Work Order ID 154931

Item ID: D3303-1 Accept ***N900040100*** Setup Start ***NS1***
 Revision ID: Stop ***NS2***
 Item Name: Plate
 Start Date: 1/4/2017 Start Qty: 2.00 ***2*** Cust Item ID:
 Required Date: 1/6/2017 Req'd Qty: 2.00 ***2*** Customer:
 Reference:

DESIGN <i>PH</i>	DRAWN BY <i>B</i>	DART AEROSPACE LTD HAWKESBURY, ONTARIO, CANADA	
CHECKED <i>PH</i>	APPROVED <i>PH</i>	DRAWING NO. D3303	REV. B SHEET 1 OF 4
DATE 06.08.17		TITLE HEAD REST	SCALE 1:3
REV	DATE	DESCRIPTION	
A	04.08.18	NEW ISSUE	
B	06.08.17	UPDATED FLAT PATTERN TO FORM PART IN ONE OPERATION USING OFFSET DIE

DRAWING NO. D3303	TITLE HEAD REST	REV. B	DART AEROSPACE LTD ENGINEERING ORDER		D.E.O. NO. D3303-B-1	SHEET NO. SHEET 1 OF 1	SCALE NTS
DRAWN AJS	CHECKED <i>h</i>	MFG. APPR. <i>h</i>	APPROVED <i>h</i>		DE APPR. <i>h</i>		
DATE 08.10.15	DATE <i>08.10.15</i>	DATE <i>08/10/16</i>	DATE <i>08/10/16</i>		DATE <i>08/10/16</i>

D3303-041 HEAD REST

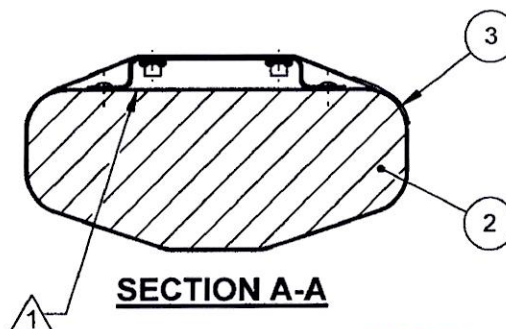
SHEET 1 ADD 1300L ADHESIVE BY 3M TO NOTE 1 AS FOLLOWS:

IS:

- 1) BOND D3305-1 FOAM TO D3303-043 BRACKET ASSEMBLY USING 3M 1300 OR 1300L ADHESIVE (0.002" TO 0.010" THICK) IN ACCORDANCE WITH MANUFACTURER'S INSTRUCTIONS
